DEPT. OF ACCOUNTING & GENERAL SERVICES DIVISION OF PUBLIC WORKS STATE OF HAWAII HILO JUDICIARY COMPLEX JUDICIARY BUILDING HILO, HAWAII					
OVERALL FIRST FLOOR PLAN					
THIS WORK WAS PREPARED BY ME OR UNDER MY SUPERVISION. <i>Mahy</i>			DARRANT MEDIA FIVE DESIGNED BY: DCO DRAWN BY: AF CHECKED BY: GS APPROVED BY: GR		DRAWN JOB NO.: 11-2-1145 DATE: 01-26-04 SHEET: 81 OF 437 SHEETS
EXP. DATE OF LICENSE: 04/30/04			SCALE: 1/16" = 1'-0"		FILE: _____ DRAWN: _____ PLOTTED: _____

DEPT. OF ACCOUNTING & GENERAL SERVICES DIVISION OF PUBLIC WORKS STATE OF HAWAII HILO JUDICIARY COMPLEX JUDICIARY BUILDING HILO, HAWAII					
OVERALL SECOND FLOOR PLAN					
DURRANT MEDIA FIVE		DATE JOB NO.		DRAWING NO.	
DESIGNED BY: DO	CHECKED BY: CG	11-2-1145	A103		
DRAWN BY: AF	APPROVED BY: GR	SHEET	82		
EXP. DATE OF LICENSE: 04/30/04		SCALE: 1/16" = 1'-0"	01-26-04		OF 457 SHEETS

OVERALL FIRST FLOOR PLAN
SCALE: 1/16" = 1'-0"

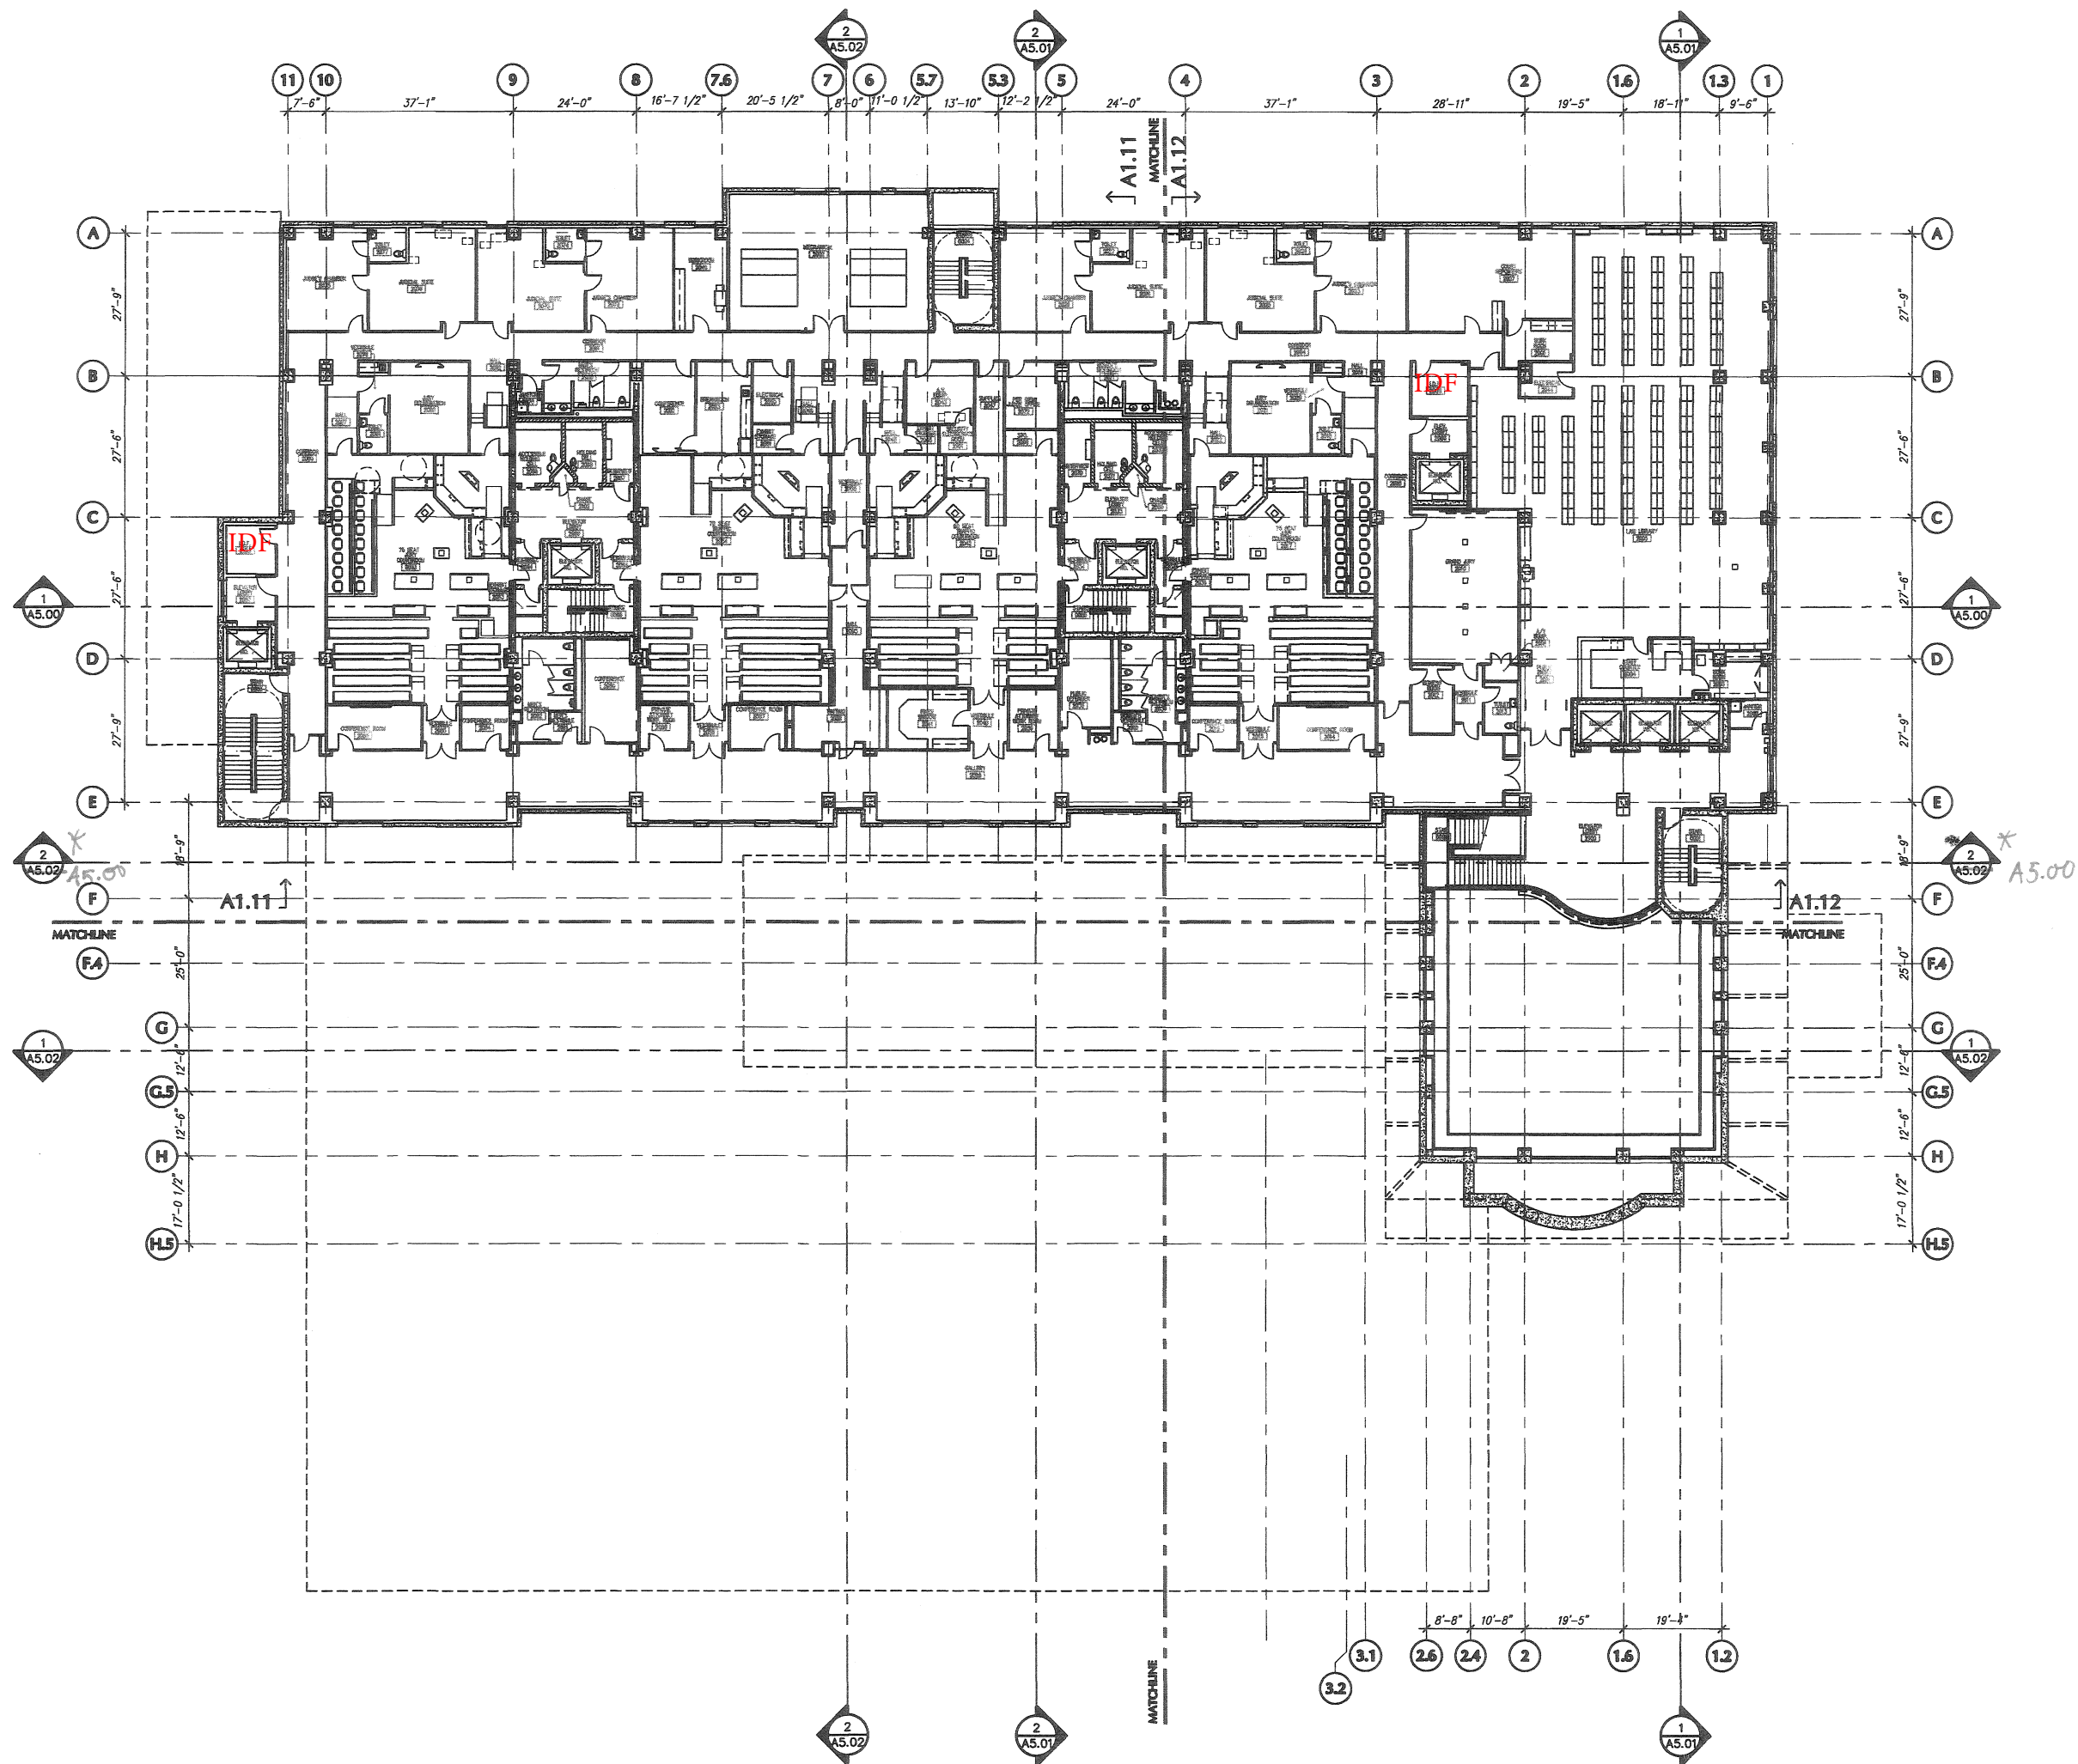
* ASI #3
item 6

OVERALL SECOND FLOOR PLAN
SCALE: 1/16" = 1'-0"

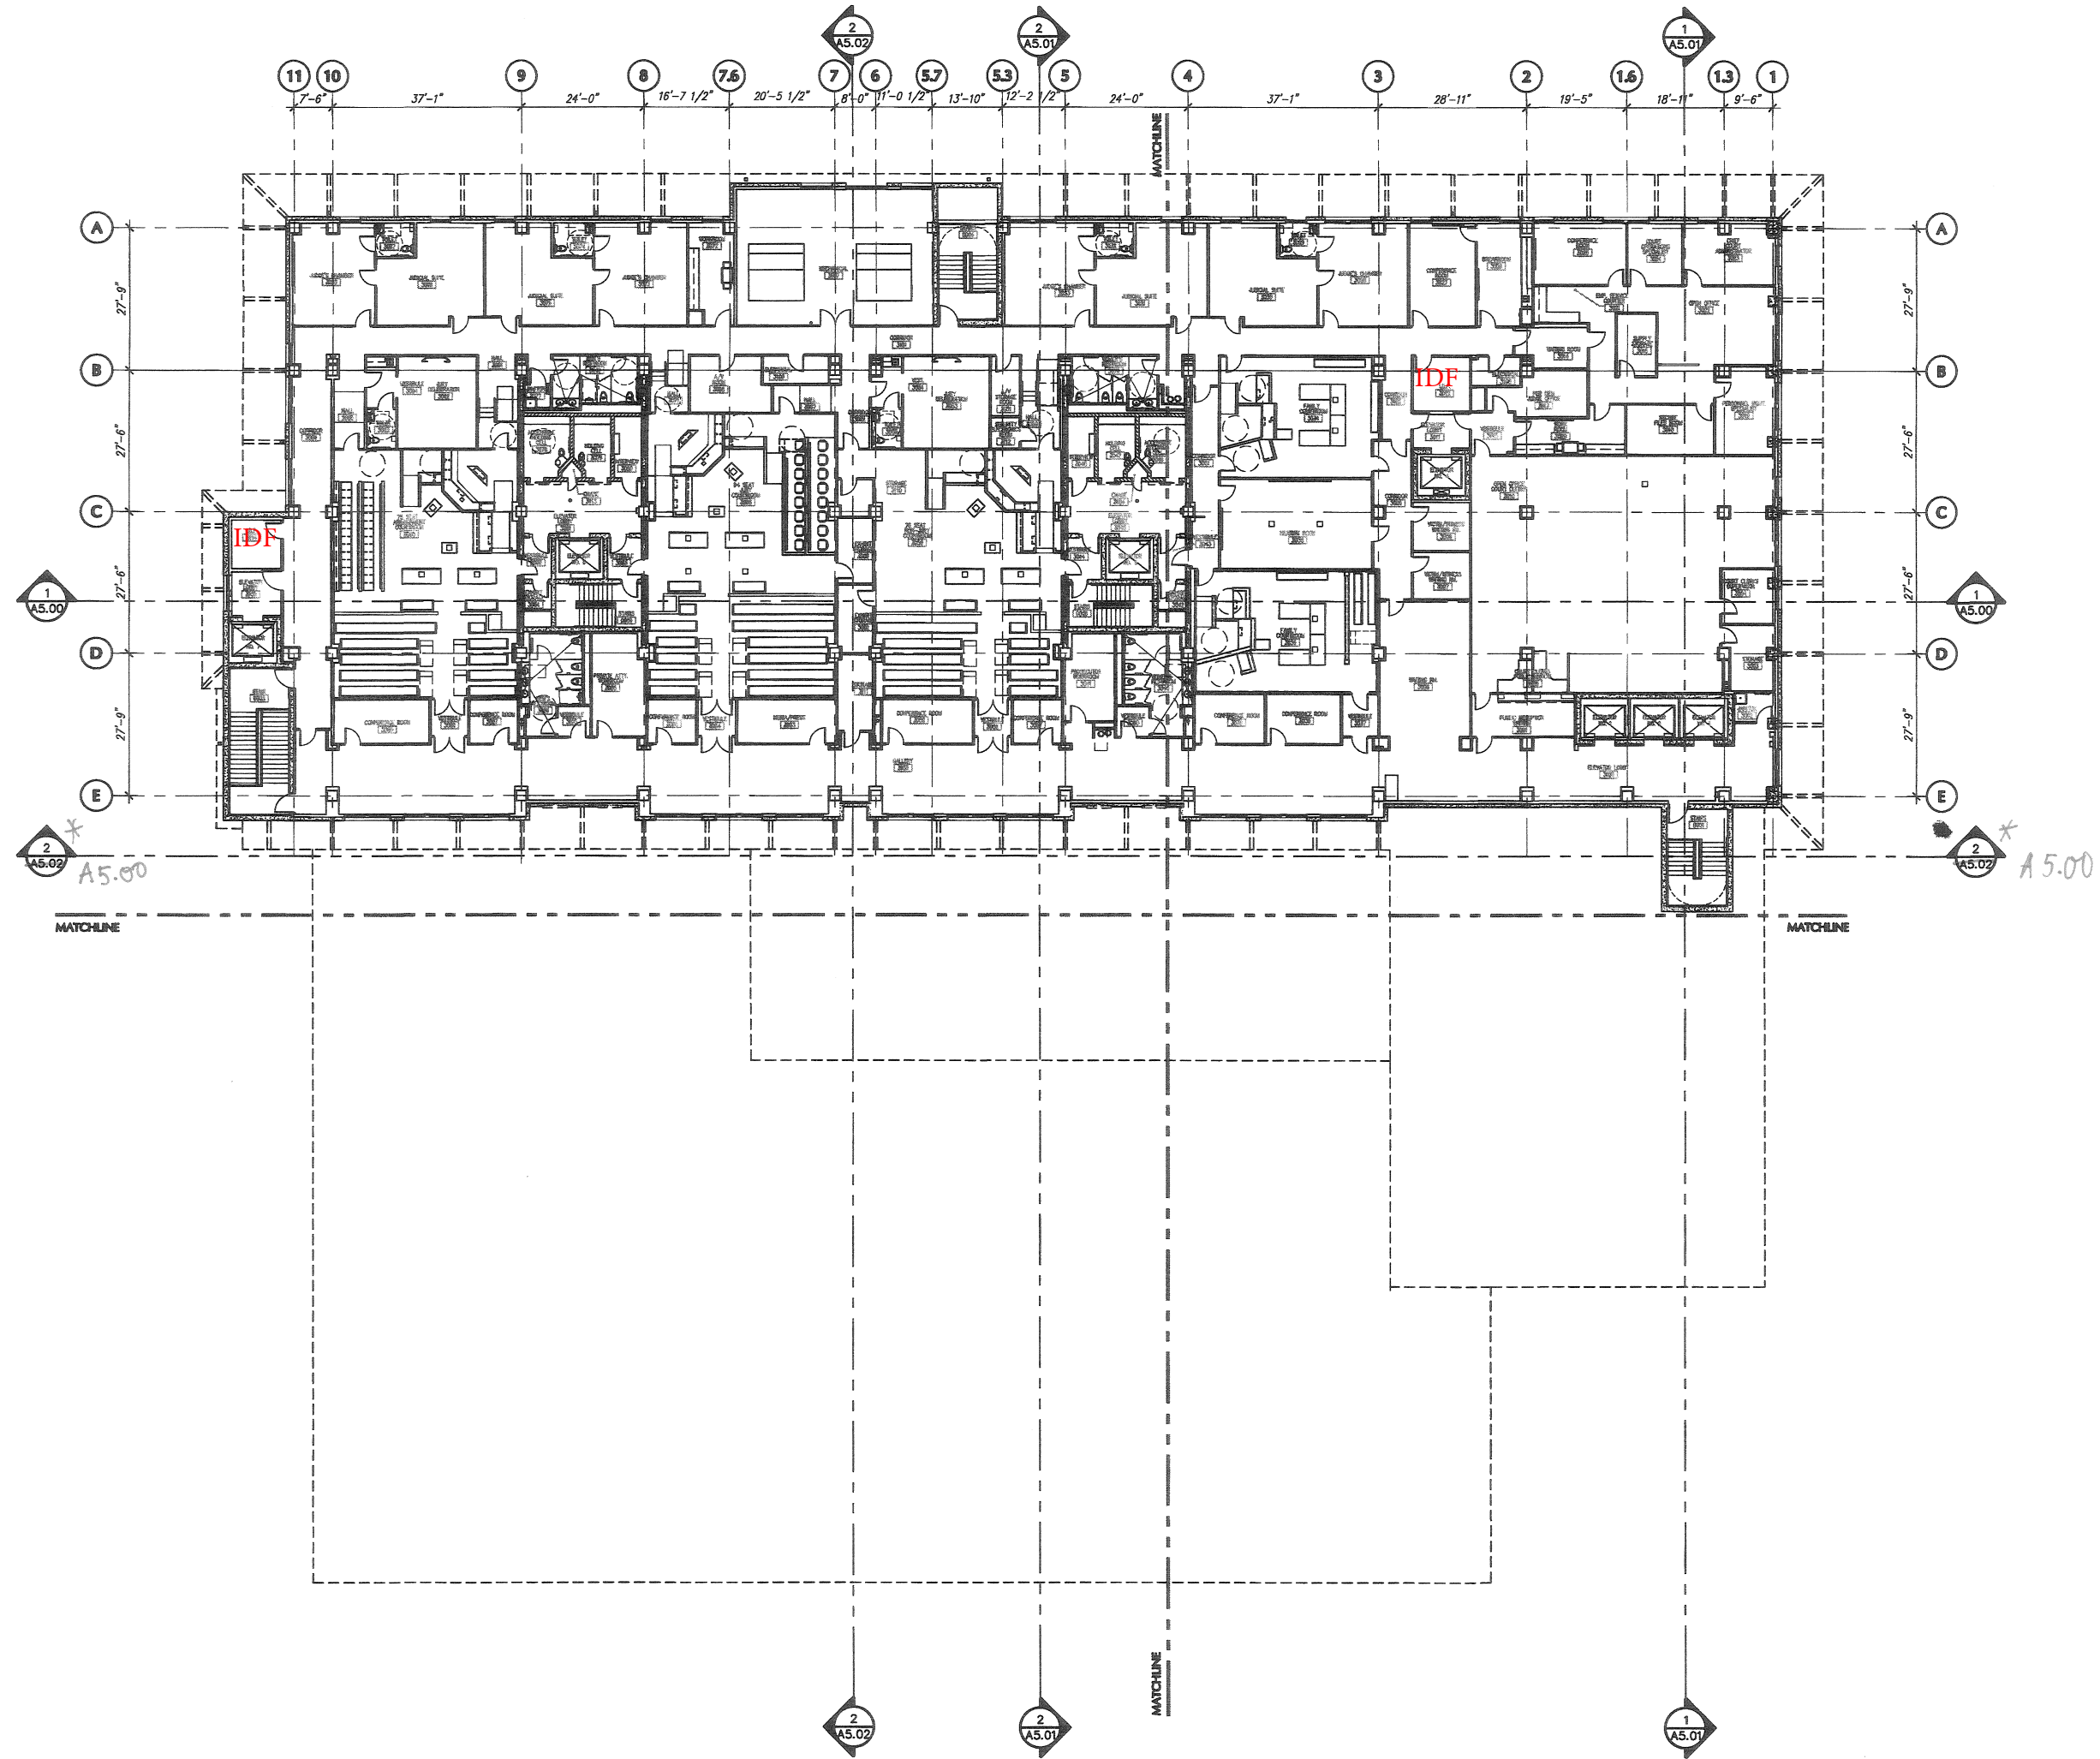
* ASI #3
item 7
